**ATTACHMENT A
MODULE 3 – PRELIMINARY DESIGN PROGRAM REVIEW
COMMENTS**

District: City of Worcester
School: Doherty Memorial High School
Owner’s Project Manager: Tishman Construction Corporation of MA
Designer Firm: Lamoureux Pagano & Associates, Inc.
Submittal Due Date: September 11, 2019
Submittal Received Date: September 10, 2019
Review Date: September 10 - October 25, 2019
Reviewed by: R.Whidden, C.Alles, J.Jumpe

MSBA REVIEW COMMENTS

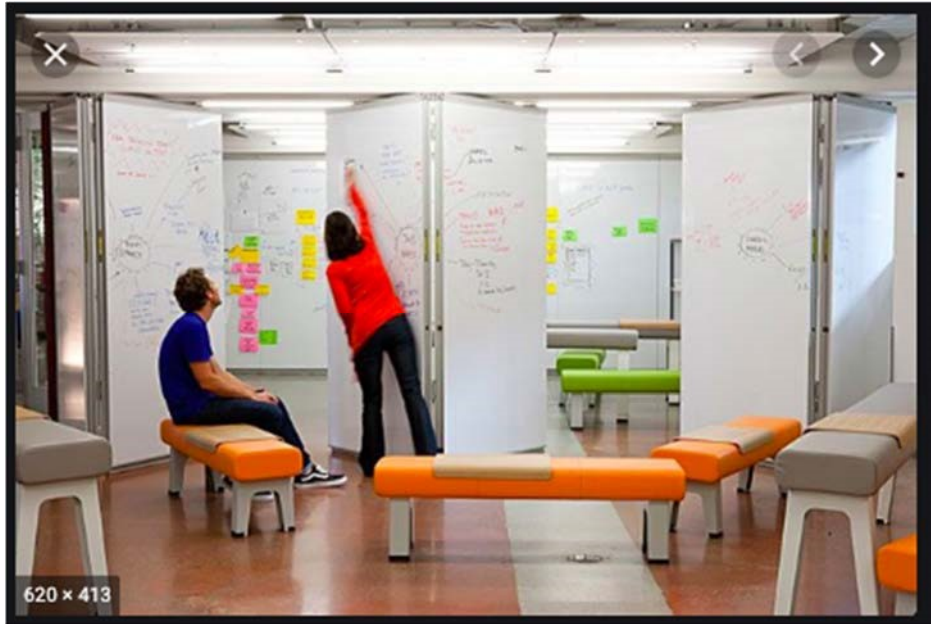
4e) The information provided notes that science labs in the current Doherty Memorial High School are clustered along a single hallway. Describe how these spaces will be arranged in the proposed project to accommodate both the current departmental organization as well as a possible shift toward a more integrated, interdisciplinary approach. Similarly, in response to these review comments, describe how spaces for each academic department – which, like science, appear to be clustered in the existing facility – will be organized in the proposed project to meet current and future needs.

District Response: (DMHS) Doherty is planning for flexible spaces to support several variations of organization to address current and future needs. This includes Grade 9 teams, with Grades 10–12 pairings between departments: for example, the English and Social Studies departments would be paired, while Mathematics and Science would also form a departmental pairing.

Additional departmental and classroom organizational information is available in the proposed adjacency diagrams provided in the PDP.

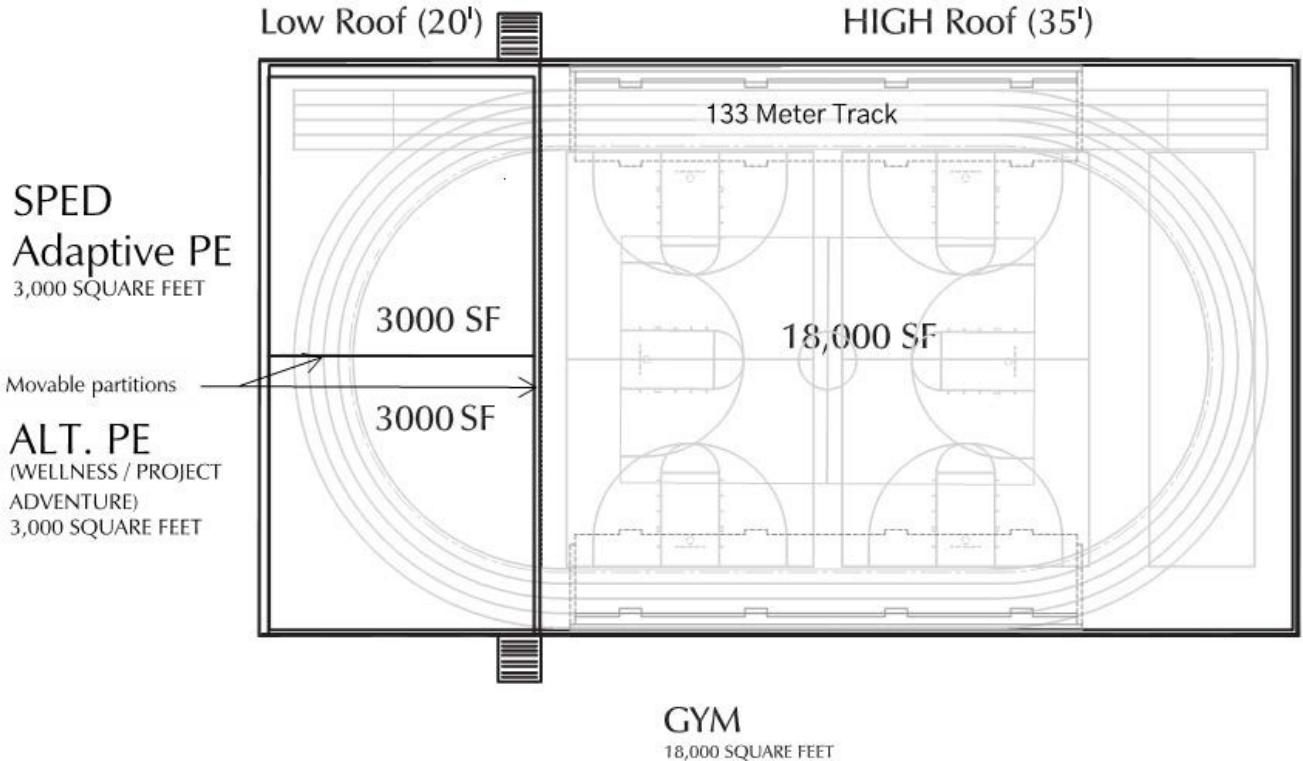
The Construction Craft Laborer program proposal seeks two classrooms and two teacher offices. The teacher offices will be shared spaces between the four program teachers. In addition, the shop area will enable students to transfer theory to practice within this versatile space. As explained in the PDP (p. 107–108), there are little to no redundancy programs within Doherty and so this shop space will enable all necessary skill sets to be introduced and mastered.

The Construction Craft Labor is the only program proposed that requires a shop ceiling height greater than a typical classroom. Layout efficiency will be considered when locating this shop within the building.
